## RESPONSE TO REQUEST FOR ADDITIONAL INFORMATION

### APR1400 Design Certification

Docket No. 52-046

RAI No.: 311-8278

**APR1400 DCD TIER 2****3.12.6.11 Pipe Support Gaps and Clearances**

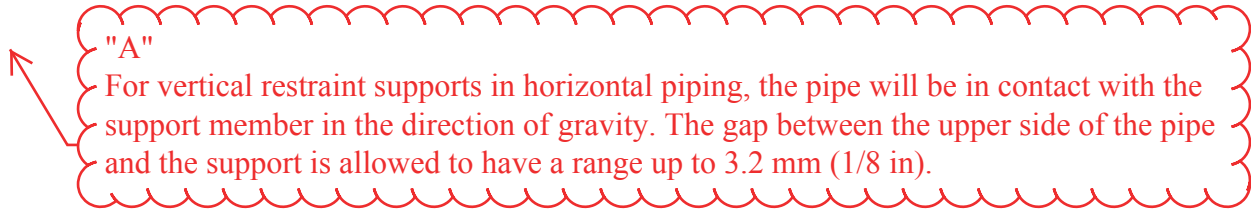
ASME BPV Code Section III, as mandated by 10 CFR 50.55a, requires that the effects of deadweight be accounted for in the piping analysis. DCD Section 3.12.6.11 states that "[t]he normal design practice for the APR1400 is to use a nominal cold condition gap of 1.6 mm (1/16 in) on each side of the pipe in the restrained direction." The above DCD statement does not appear to be applicable to pipe restraints that are designed to support deadweight. The applicant is requested to provide additional information on gaps that are used in deadweight support restraints.

Insert "A" from next page.

"A"  
For vertical restraint supports in horizontal piping, the pipe will be in contact with the support member in the direction of gravity. The gap between the upper side of the pipe and the support is allowed to have a range up to 3.2 mm (1/8 in).
